VEHICLE RECALL STOP SALE ORDER

G-05513
May 2005

SUBJECT: VEHICLE RECALL/STOP SALE ORDER (U.S., EXP.)
BRAKE PUSH ROD in Driver Control Module (DCM) on
certain 3200, 4000, 7000, and 8000 Series Models built
4/5/2005 thru 5/11/2005

G-05513-R1
May 2005

Figure 1 – Push Rod Location

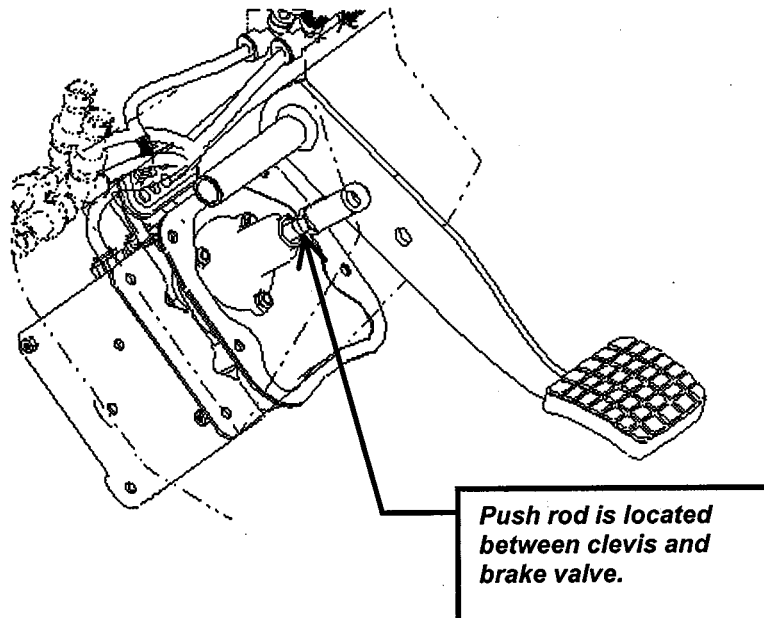
INTERNATIONAL has just been made aware that a brittle, air brake push rod (see Figure 1) was installed in air brake vehicles with driver control modules (DCM). This push rod may break prematurely and result in a loss of braking ability. This may cause a **vehicle crash without warning**, which may result in **property damage, personal injury, or death.**

Note: NO ADJUSTMENT OF THE CLEVIS IS NEEDED. ALL CLEVIS LOCATIONS ARE PRESET. DO NOT CHANGE THE CLEVIS LOCATION ON THE PUSH ROD.

Figure 1 – Push Rod Location

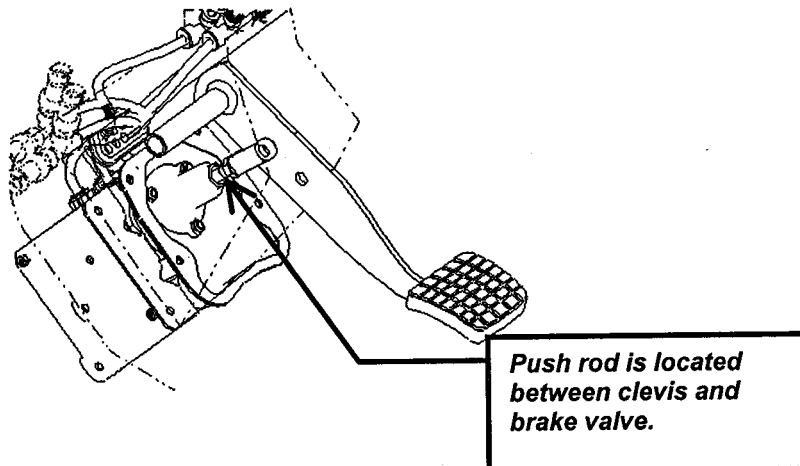
INTERNATIONAL has just been made aware that a brittle, air brake push rod (see Figure 1) was installed in air brake vehicles with driver control modules (DCM). This push rod may break prematurely and result in a loss of braking ability. This may cause a **vehicle crash without warning**, which may result in **property damage, personal injury, or death.**

Note: NO ADJUSTMENT OF THE CLEVIS IS NEEDED. ALL CLEVIS LOCATIONS ARE PRESET. DO NOT CHANGE THE CLEVIS LOCATION ON THE PUSH ROD.
